MINERALS PROGRAM INSPECTION REPORT

| MINE NAME: Cresson Project | MINE/PROSPECTING ID#: M-1980-244 | MINERAL: Gold | COUNTY: Teller |
| INSPECTION TYPE: Monitoring | INSPECTOR(S): Amy Eschberger, Patrick Lennberg | INSP. DATE: October 30, 2018 | INSP. TIME: 09:45 |

Photo 1. Interior view of Adsorption-Desorption Recovery Plant No. 2 (ADR-2) located in Squaw Gulch Valley Leach Facility.

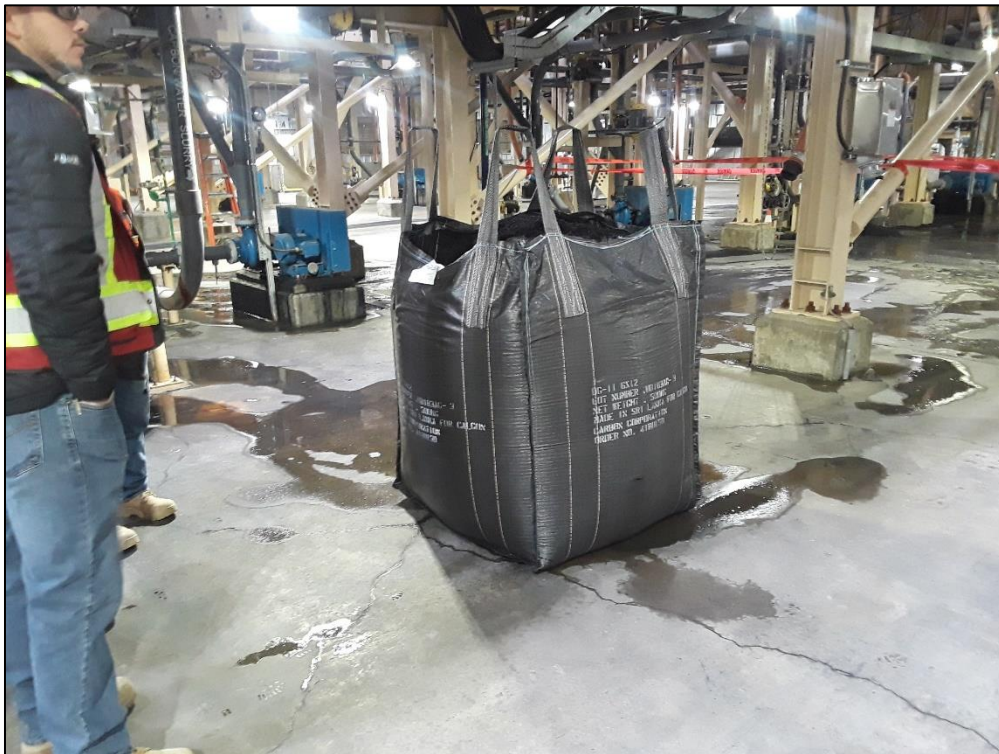
The Division inspected the interior and exterior of the ADR-2 plant (**Photos 1-4**) located in the Squaw Gulch Valley Leach Facility (SGVLF).

Photo 16. View looking southeast, showing approximate 10,050 foot lift (circled in yellow) placed in northeastern portion of SGVLF, just north of HGM facility. This photo was taken from the Division's 2/27/18 inspection report.

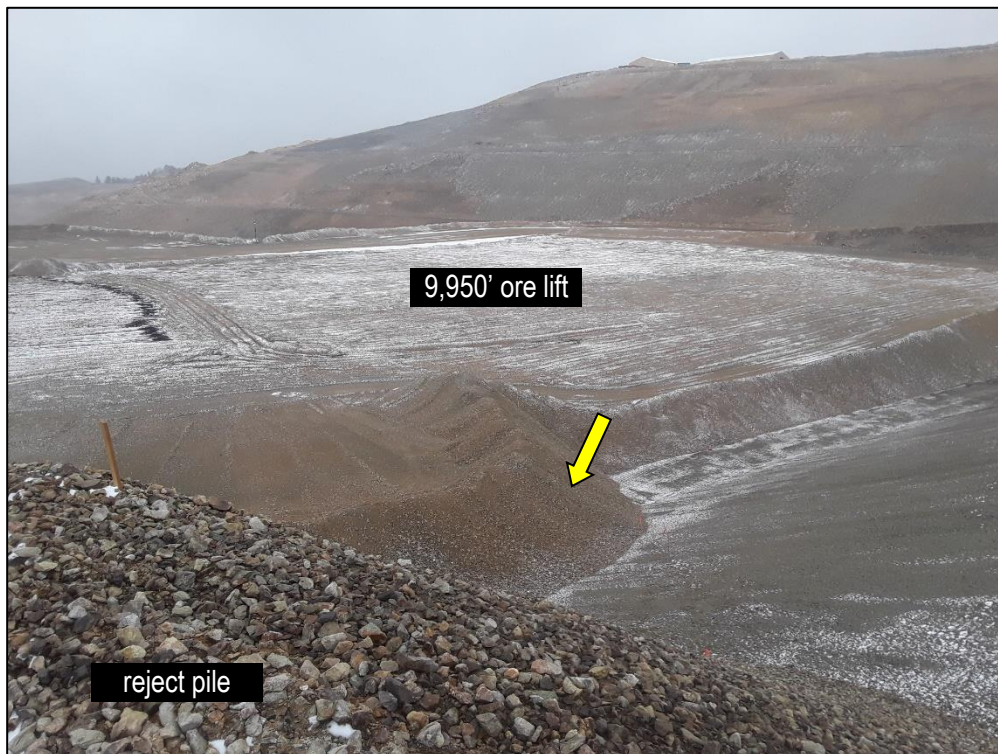
The Division inspected the reject pile area located at the 10,050 foot elevation level in the SGVLF, just north of the High Grade Mill Facility (**Photo 16**). Placement of this pile was not approved in the permit, thus, the Division cited a problem for this activity in its inspection report for February 27, 2018. The operator submitted Technical Revision No. 100 (TR-100) to address this matter, including plans for temporarily buttressing the reject material until it can be removed down to the DCF, and the liner beneath the pile inspected to ensure it was not damaged by this activity. At the time of the current inspection, the reject pile had been temporarily buttressed by ramping up the 9,950 foot ore lift (**Photo 17**).
